STAFF RECOMMENDATION

1101 Paris Avenue
September 16, 2020

Application: New Construction – Addition; Setback Determination
District: Waverly-Belmont Neighborhood Conservation Zoning Overlay
Council District: 07
Base Zoning: R8
Map and Parcel Number: 118010173.00
Applicant: Paul Boulifard
Project Lead: Jenny Warren, jenny.warren@nashville.gov

<p>Description of Project: Application for the construction of a rear addition.</p> <p>Recommendation Summary: Staff recommends approval with the following conditions:</p> <ol style="list-style-type: none">1. Staff approve the final materials prior to purchase and installation, including: the foundation material, the roofing color, the doors, the windows, the side stair and rear deck materials; and2. The HVAC shall be located behind the house or on the interior side, beyond the mid-point of the house, <p>finding that the project meets Sections III and IV of the <i>Waverly-Belmont Neighborhood Conservation District: Handbook and Design Guidelines</i>.</p>	<p>Attachments A: Photographs B: Site Plan C: Elevations</p>
---	--

Figure 2: Right side elevation

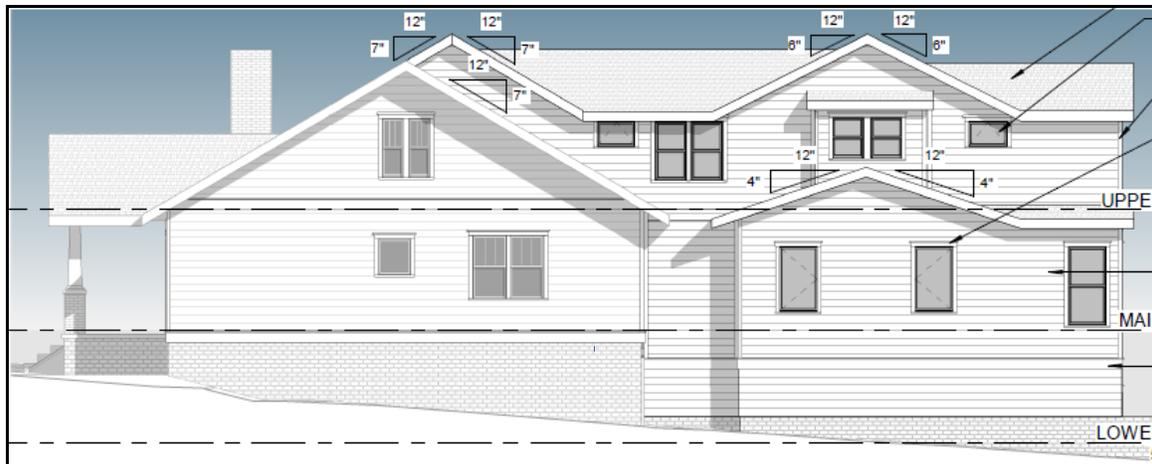
Height & Scale: The project includes a two foot (2') tall ridge-raise that will extend the front slope up and to the rear, stepping in two feet (2') from each side to preserve the gable ends, eaves, and a portion of the original roof. The Commission has routinely found ridge-raise additions like this to be appropriate.

The roof of the rear addition will have a cross-gable “hyphen” tying into the raised roof ridge and extending back to another side-gabled component at the rear, parallel to the original roof.

The addition will be stepped in from the side walls of the house by two feet (2') on the first and second stories, preserving the original back corners of the house. After extending about seven feet (7') to the rear, the addition will step back out to match the width of the house on the first story. The upper-story walls will remain inset two feet (2'), with the exception of an eight foot (8') wide bay that steps back out one foot (1') on either side. (Figures 2 and 3)

Exceptions include some shorter windows on the second story, which could be appropriate, as historically houses often have shorter windows on upper floors. There are also two small horizontal windows on the second floor of the left elevation (Figure 2). These could be appropriate as they are well beyond the midpoint of the historic house and are accent windows rather than the dominant window form. There are no large expanses of wall space without a window or door opening. Staff finds the project’s proportion and rhythm of openings to meet Section III.G. for new construction-proportion and rhythm of openings.

Figure 3: Left side elevation

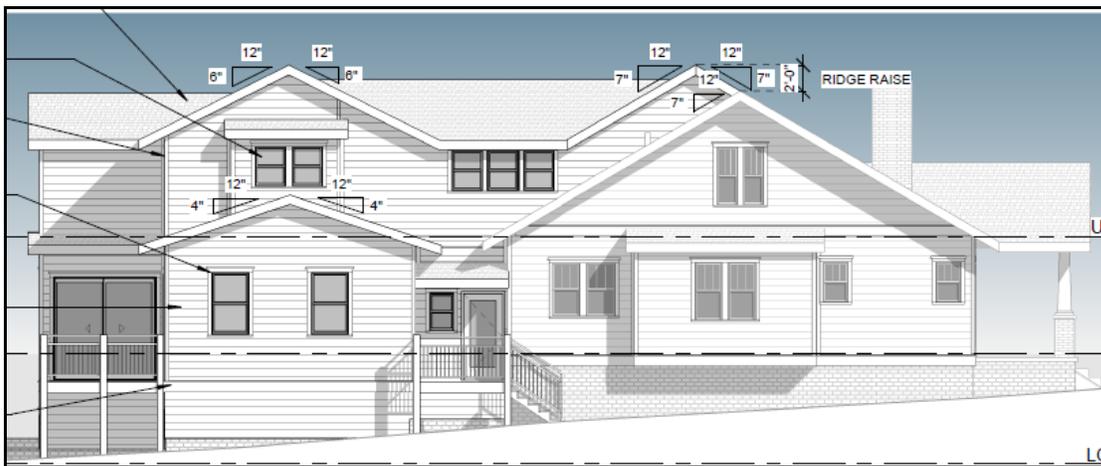
On the left side, the first floor will step back out even with a protruding bay on the original house, rather than with the main wall. The Commission has approved similar configurations in the past. This side also includes an uncovered side stair and an uncovered rear deck. (Figure 3)

By stepping in the ridge raise and keeping the scale of the two-story massing of the addition inset two feet (2') from the side walls of the historic house, staff finds the scale of the addition to meet section IV.B. for additions-massing.

Figure 4: Proposed site plan

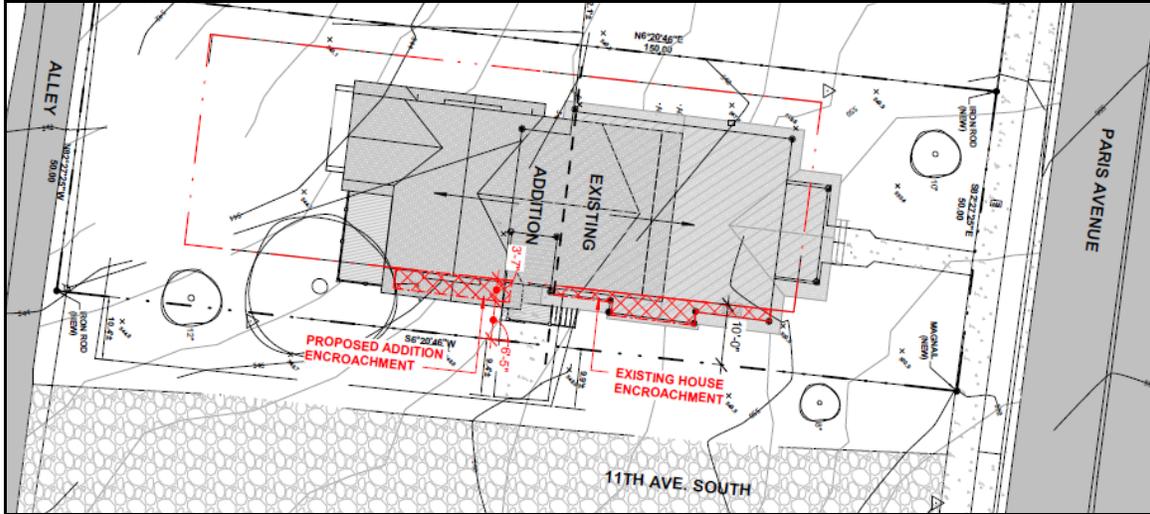
Setback & Rhythm of Spacing: The front setback will not be impacted by this project. The rear setback will be approximately forty-five feet (45'). The right side setback will remain six feet (6'). All of these meet the base zoning.

The left side will require a setback determination. The historic house sits about six feet, five inches (6'5") from the side property line. Although 11th Avenue South is maintained and functions as an alley in this location, it is technically a street, thus the side setback required by base zoning here is ten feet (10'). The addition will step out such that the exterior side wall aligns with the side wall of the historic house, thus it will be about three feet, seven inches (3'7") into the side setback. The uncovered side stairs and landing will be just over three feet (3') from the side property line. Staff finds that this condition

could be appropriate for several reasons. First, the addition will be no closer to the side property line than the historic house already is. Second, although the house is six feet, five inches (6'5") from the property line, the property line itself is well recessed from the street, with about ten feet (10') of undeveloped right-of-way. While the street could be widened, or a sidewalk could eventually be constructed, this is unlikely, as this section of the street terminates at the alley. Thus, the addition will effectively be a full sixteen feet (16') from the road, as is the house. Lastly, because this section of 11th Avenue South is maintained as an alley, reducing the setback to six feet, five inches (6'5") could be appropriate, since the setback required for an alley is only five feet (5').

Staff finds that the project meets section III.C for setback for new construction.

Figure 6: Model from the back corner at the alley.

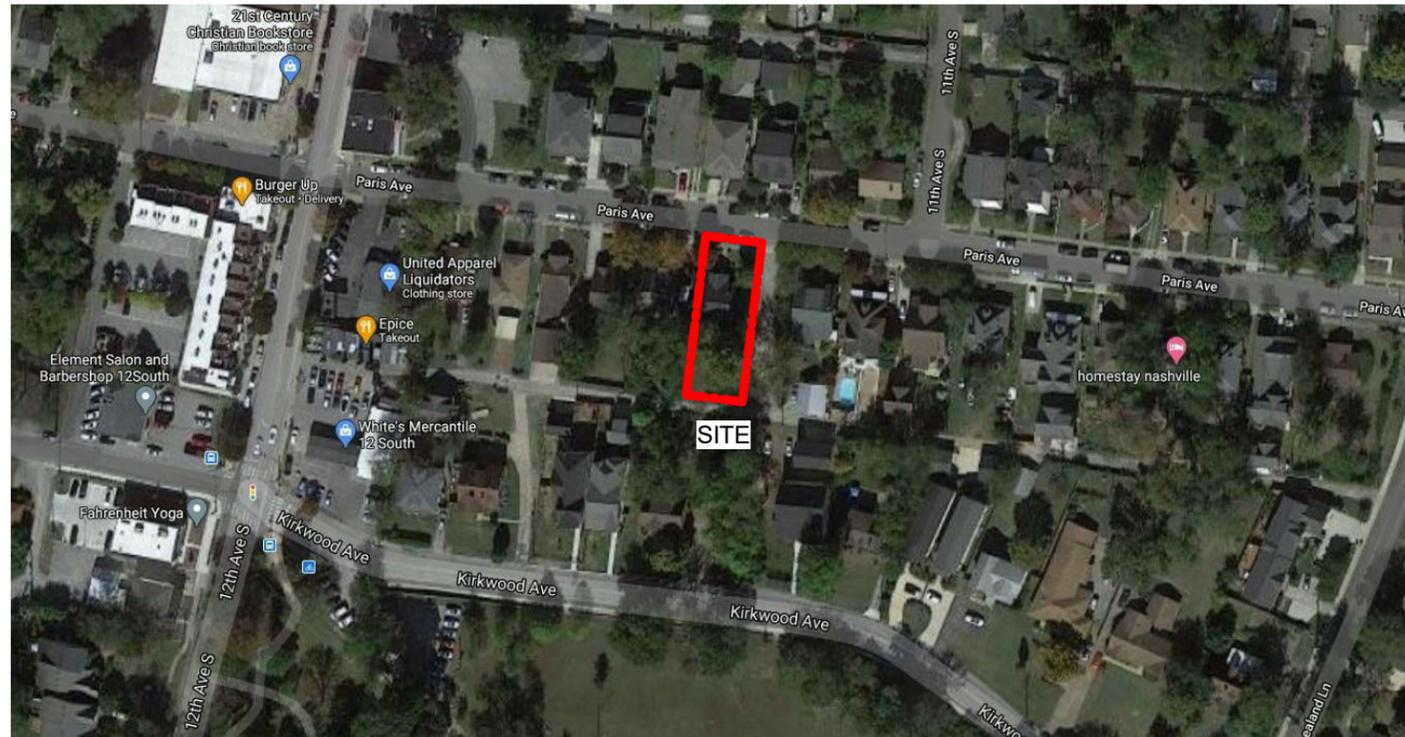
Roof form: The slope of the ridge raise will match the historic house at 7/12. The primary roof of the addition will be a cross-gable with a 6/12 pitch. The shed roofs on the two upper story bays will be 5/12 and the slope on the first story eaves will be 4/12. These roof forms and pitches are common on historic houses throughout the area and are compatible with the historic house. Staff finds that the project meets Sections III.E for new construction-roof form and IV.C for additions.
